CHARGING SYSTEM IMPROVEMENT

Prevost vehicles

DESCRIPTION

FIGURE 7

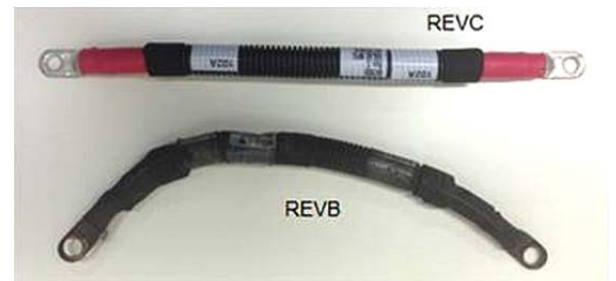
6. Reinstall the jumper cable **#067835 revision C** included in kit #7770176 (FIGURE 5, FIGURE 6).

Rev.C lug terminal through hole diameter= 5/16" **CORRECT**

Rev.B lug terminal through hole diameter= 13/32" **INCORRECT**

Rev.B diameter of the through hole is too large, reducing contact surface with the stud and the nut thus reducing electrical conductivity between the lug and the alternator stud (FIGURE 7).

FIGURE 8

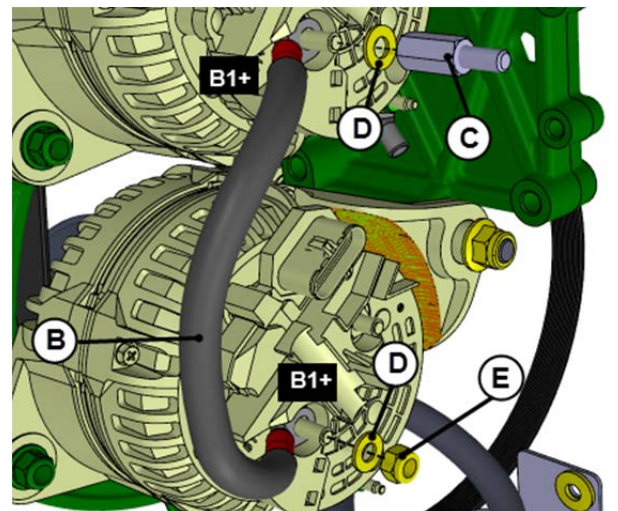
7. Reinstall appropriate jumper cable **B** (i.e. rev.C) with appropriate stud adapter. Refer to FIGURE 8.

B : JUMPER CABLE #067835 revision C

C : STUD ADAPTER #564590 *torque: 10 lbf-ft*

D: FLAT WASHER #5001341

E: NUT M8 #5001787 *torque: 10 lbf-ft*

FIGURE 9

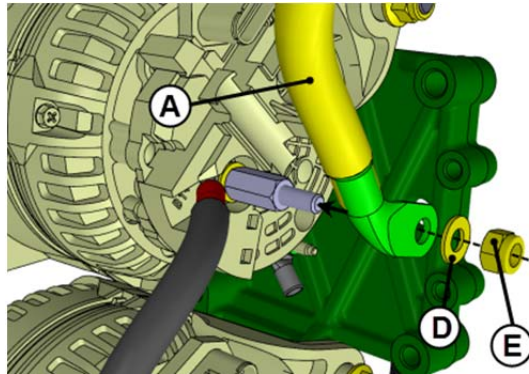
8. Reinstall power cable **A**. To do so, connect power cable **A** to the upper alternator **B1+** stud terminal. Refer to **FIGURE 9**.

A : POWER CABLE

D: FLAT WASHER #5001341

E: NUT M8 #5001787 *torque: 10 lbf-ft*

FIGURE 11

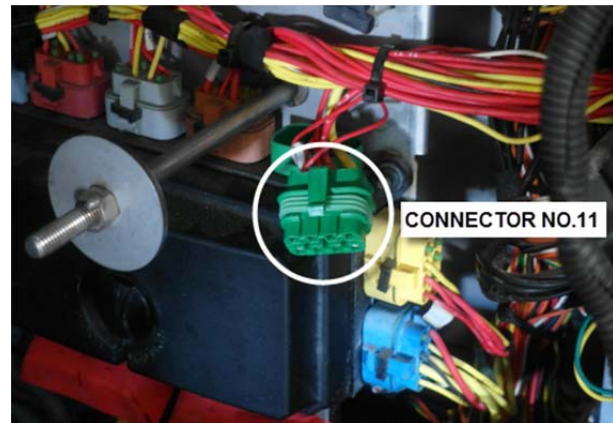
3. Using an extractor tool or a small flat blade screwdriver, remove wire 24VDALT from cavity H of connector no.11 (FIGURE 11 to FIGURE 14).

FIGURE 14

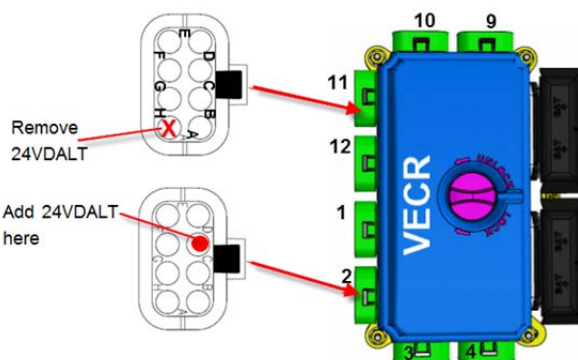
4. Relocate wire 24VDALT to cavity **C** of connector no.2 (red) on the harness.

Cavity **C** of connector no.2 should be available. This branch of the circuit will be protected by 10A fuse F64 (see FIGURE 16 below).

FIGURE 16 : WIRING DIAGRAM PAGE 5.1

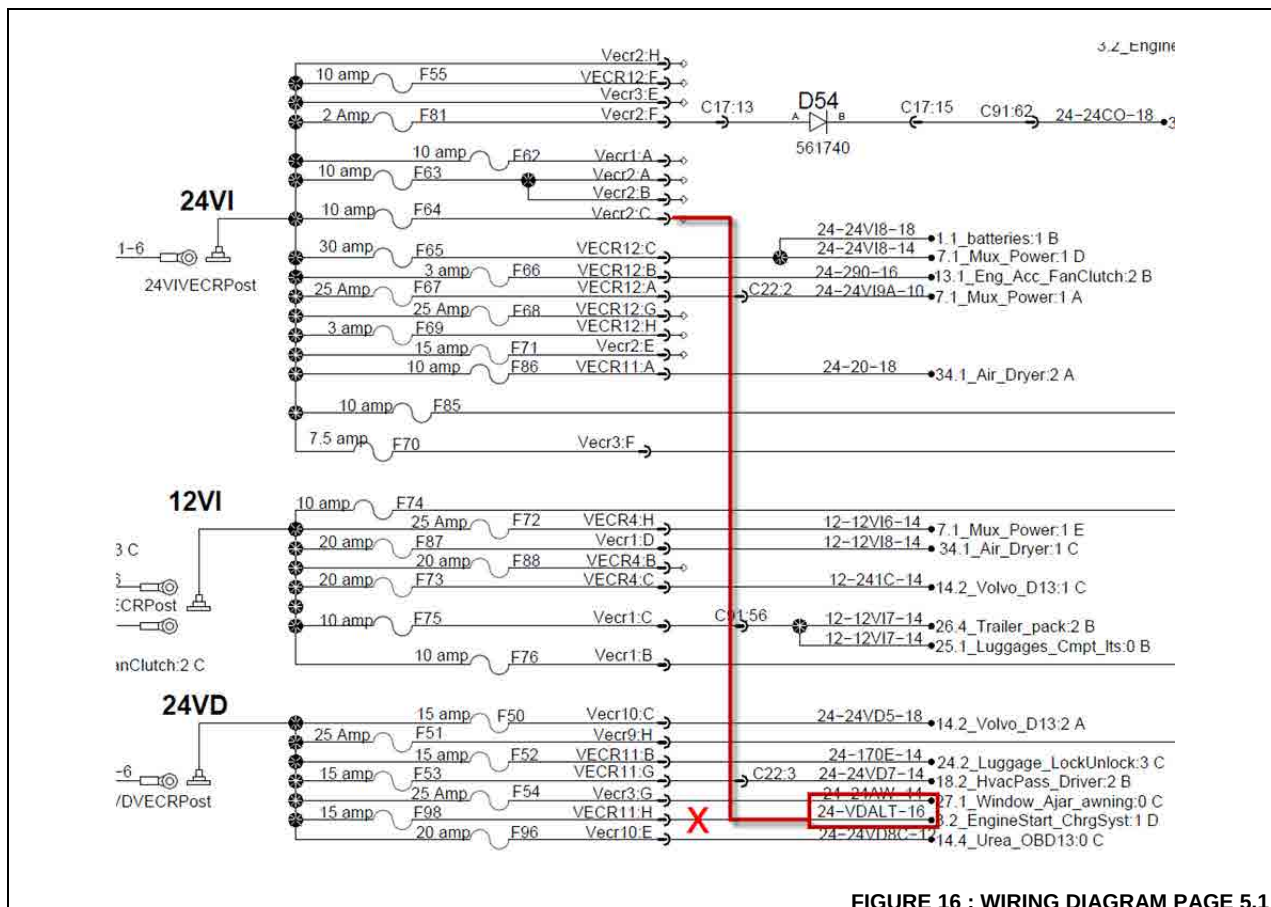
Should cavity C not be available, refer to your vehicle wiring diagram page 5.1 to select another free cavity protected by a 10A or 15A fuse (see FIGURE 16 for reference).
